### ANN ARBOR HISTORIC DISTRICT COMMISSION

### Staff Report

346 E Kingsley St, Application Number HDC19-161 ADDRESS:

**APPLICATION:** The applicant seeks HDC approval to install one 22 <sup>1</sup>/<sub>2</sub>" x 37 <sup>1</sup>/<sub>2</sub>" skylight on the front half of the south-facing roof face.

## Proposed Skylight (22 ½" x 37 1/2") with approximate location

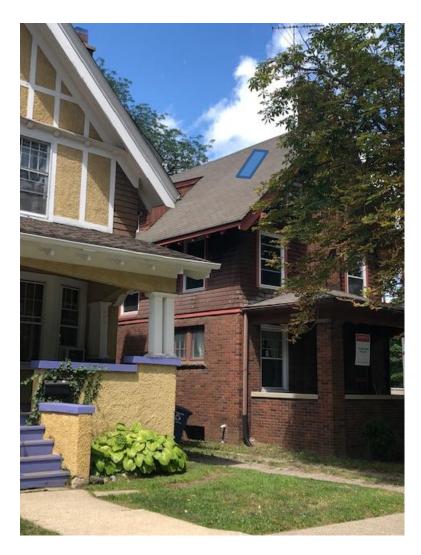
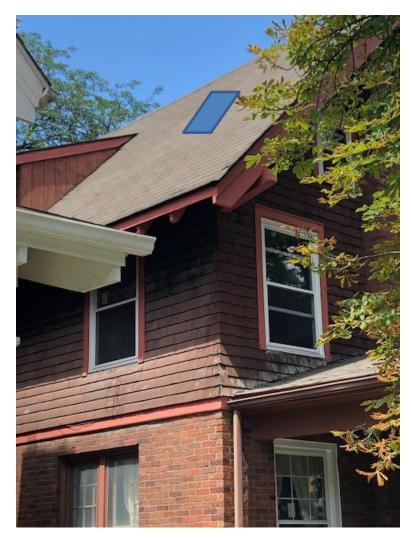
- The proposed skylight is 22 <sup>1</sup>/<sub>2</sub>" x 37 <sup>1</sup>/<sub>2</sub>" and would be located below the chimney, between the N. Division Street roof edge and a shed dormer centered on the asphaltshingle roof. The skylight is a dark color and maintains a low profile.
- 2) The window is compatible in size and design. It is visible from the street, but is inconspicuous, does not impact any character-defining features of the house, and is reversible. Staff believes the work meets the SOI Standards and Guidelines, and the Ann Arbor Historic District Design Guidelines.

I move that the Commission issue a certificate of appropriateness for the application at 346 E Kingsley Street, a contributing property in the Old Fourth Ward Historic District, to install a skylight on the south-facing roof, as proposed. The work is compatible in exterior design, arrangement, texture, material and relationship to the rest of the building and the surrounding area and meets *The Secretary of the Interior's Standards for Rehabilitation*
